Wichita-Sedgwick County Metropolitan Area Planning Department

RE: **BZA2018⁹-00034**: Sign Code Adjustment to permit an electronic message center on a new monument sign for religious institution located in TF-3 Two-Family Residential.

Legal Description: LOT 1 BLOCK A & PT VAC CHAUTAUQUA CIR ADJ (29758240) HOLY SAVIOR ADDITION, Wichita, Sedgwick County, Kansas. Generally located two blocks west of the intersection of North Hillside Avenue on the north side of East 13th Street North (3000 E 13th Street North)

Site Plan

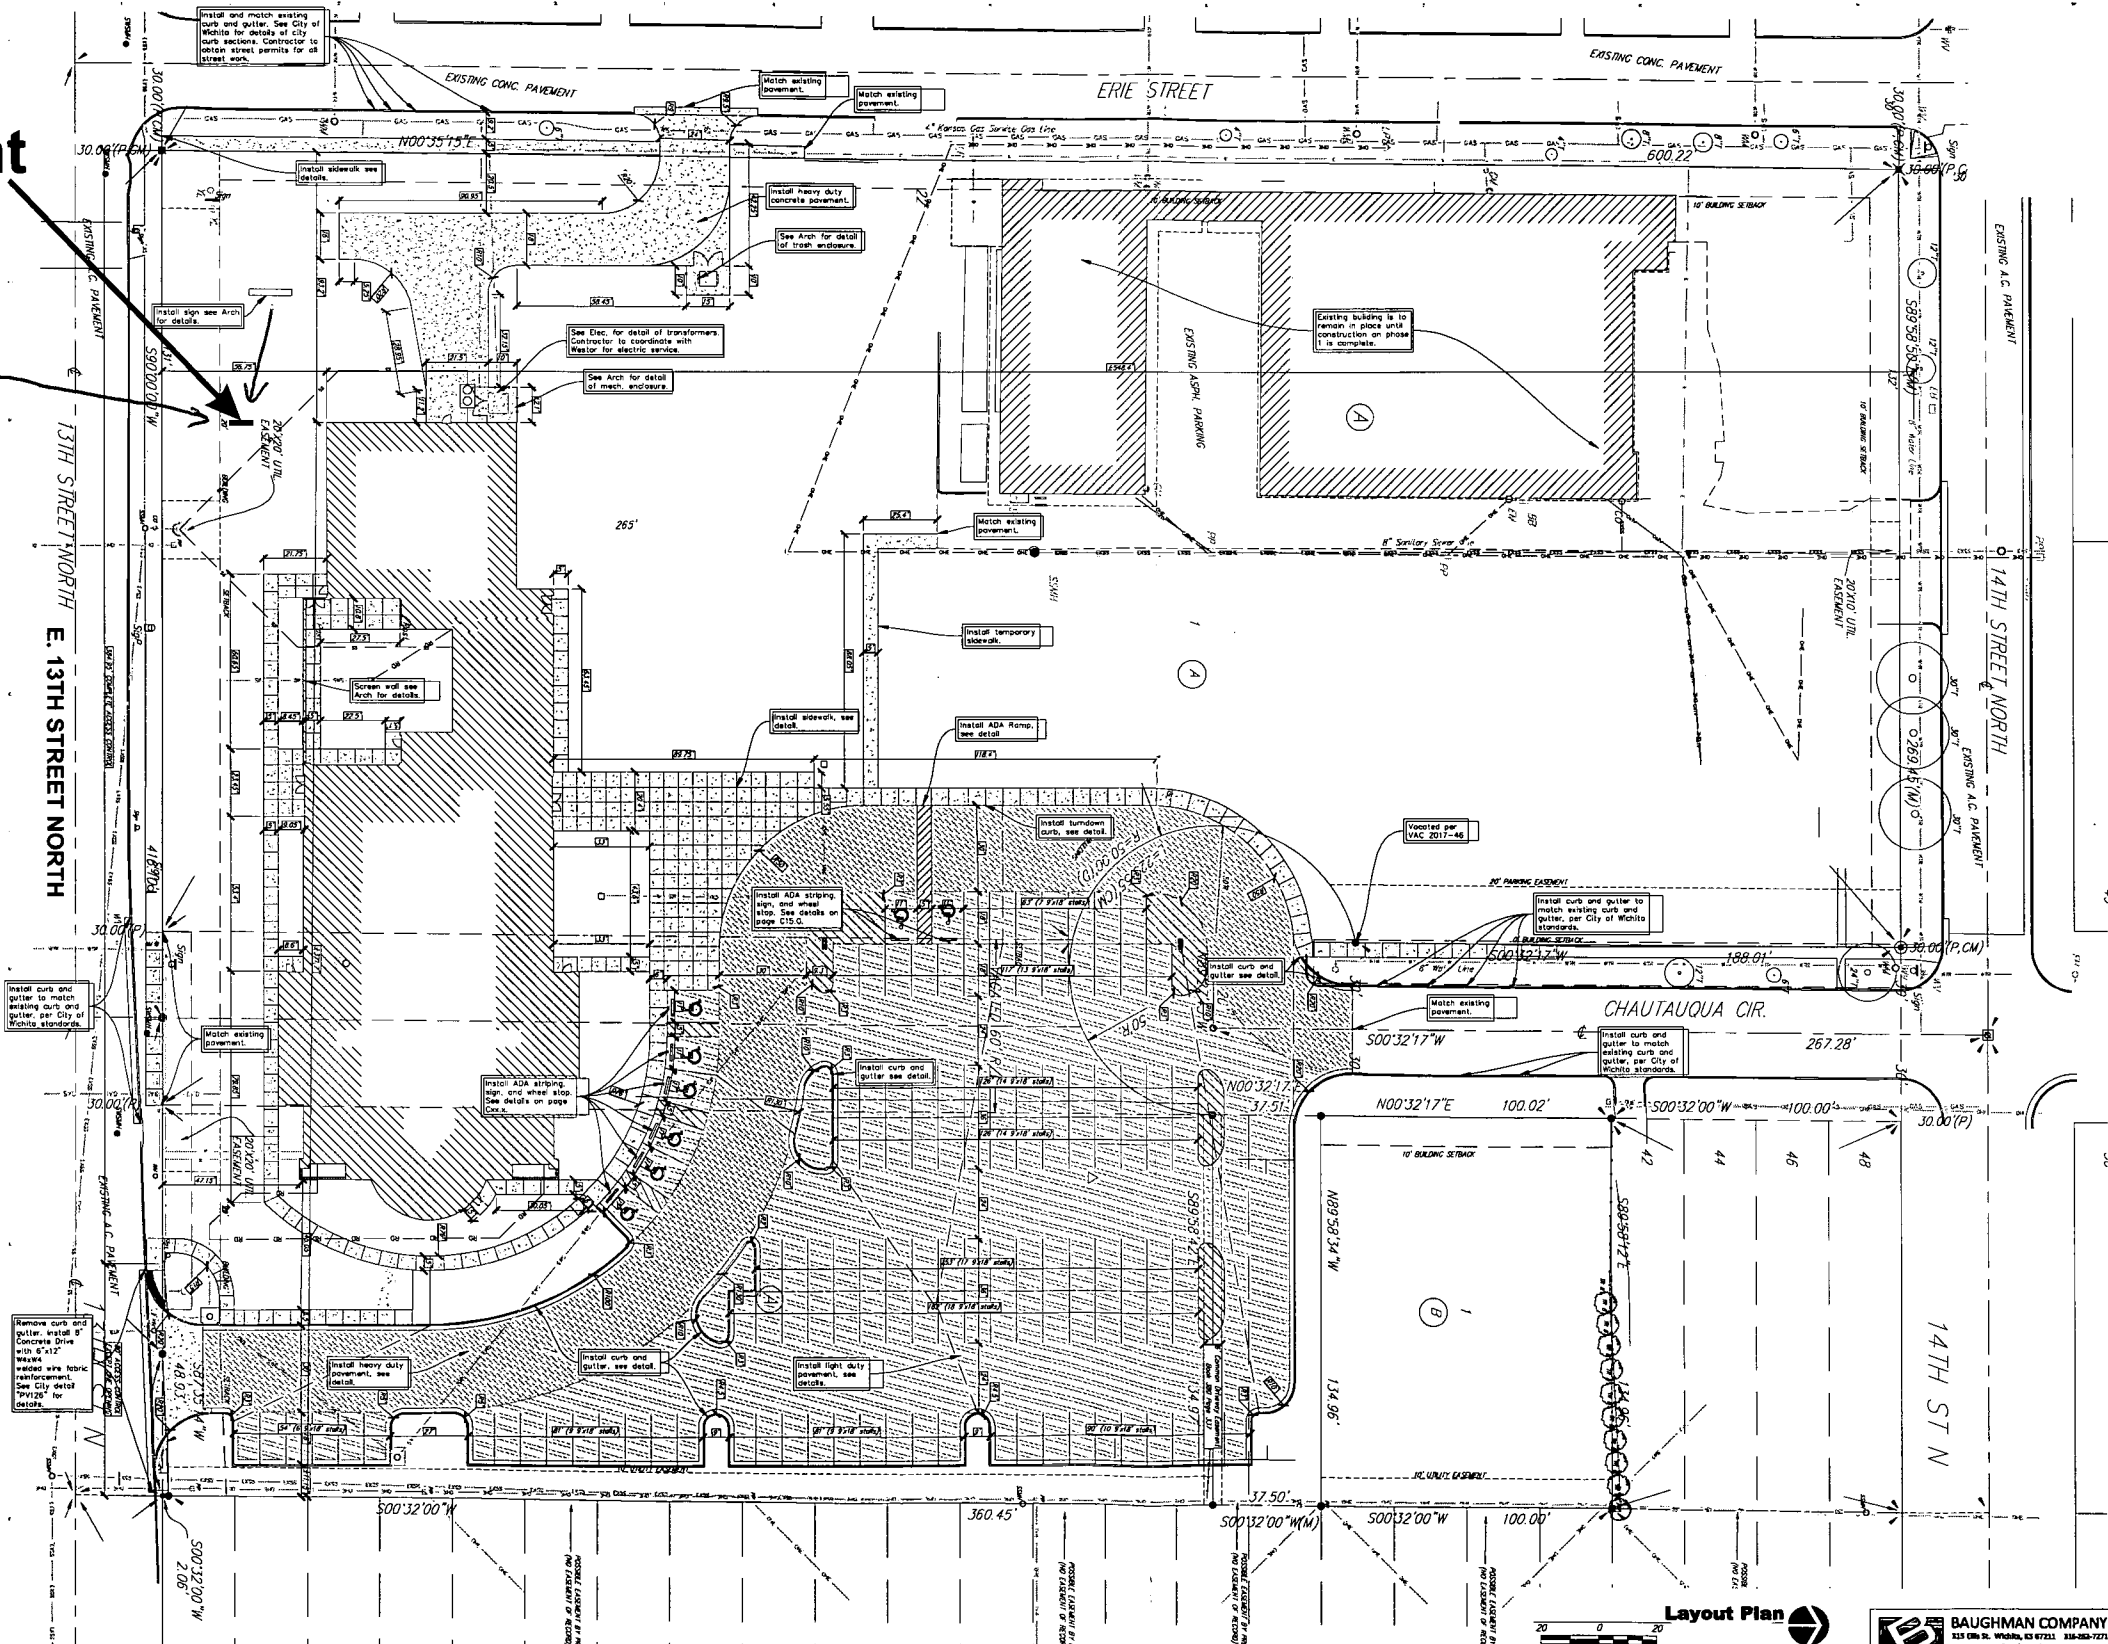
Install
Monument
Sign
Here
*correct
location*

APPROVED 9/25/19 BY *Blanca*

1 D/F LED Monument Sign

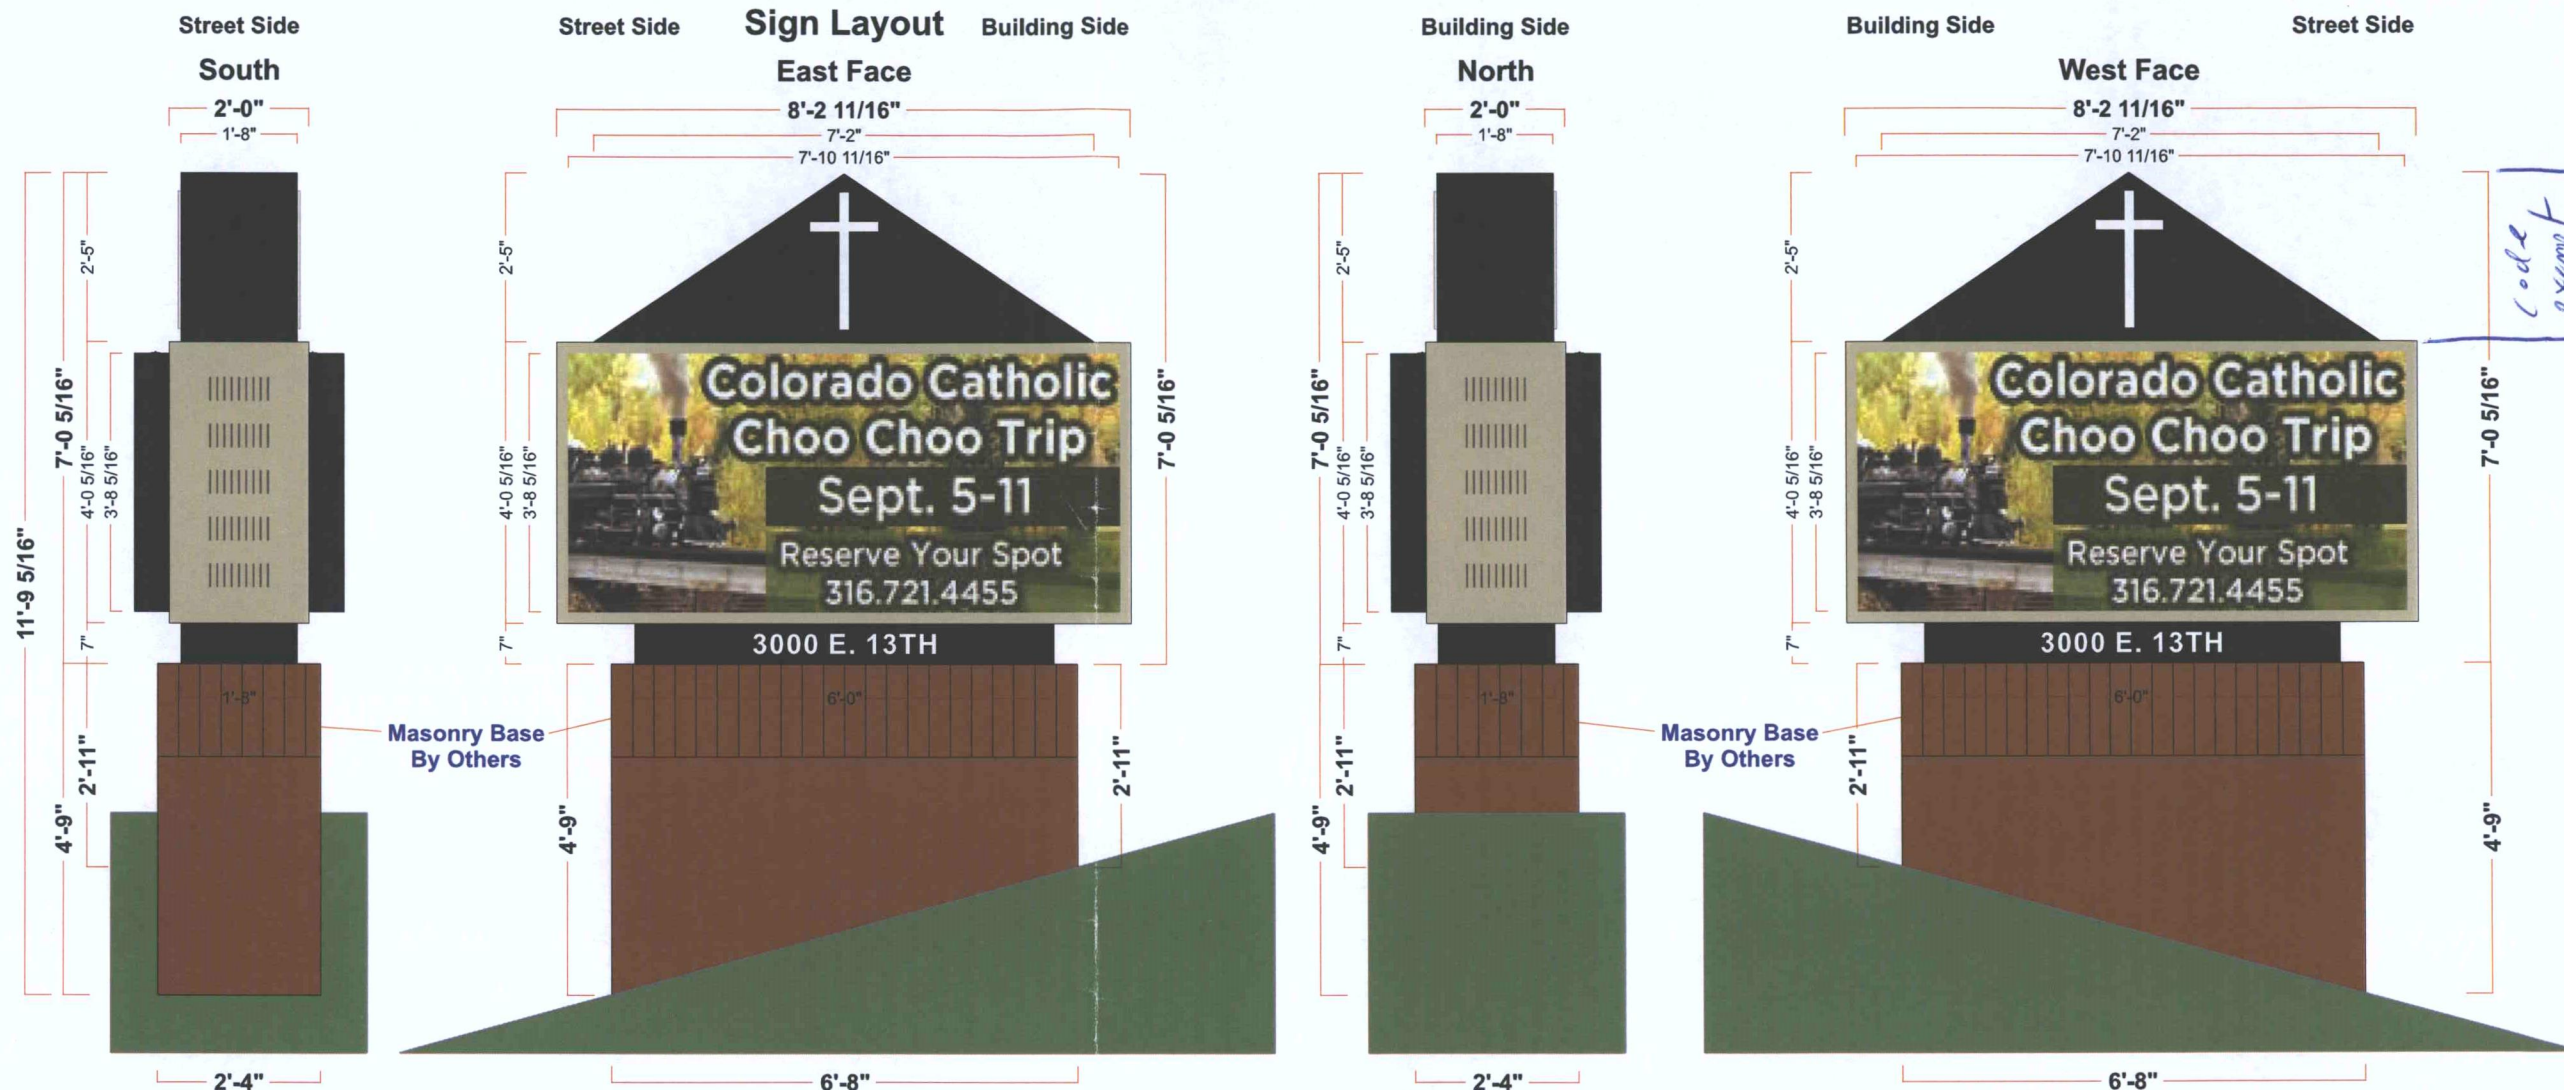
- 1) The administrative adjustment is for a monument sign (6'-5" tall by 8'-1" wide) with a LED component that has 32.4 square feet on each side in TF-3 zoning; all signage on the site shall otherwise conform to the Sign Code unless a separate adjustment or variance is approved.

- 2) The sign shall be in conformance with the approved elevation and site plan. The sign shall be permitted and installed within one year from the date of approval.

- 5) The sign shall not make copy or graphics changes faster than once per second.
- 6) No other freestanding signs shall be allowed on the subject site.

SITE PLAN
APPROVED 9/25/19 BY *Blm*
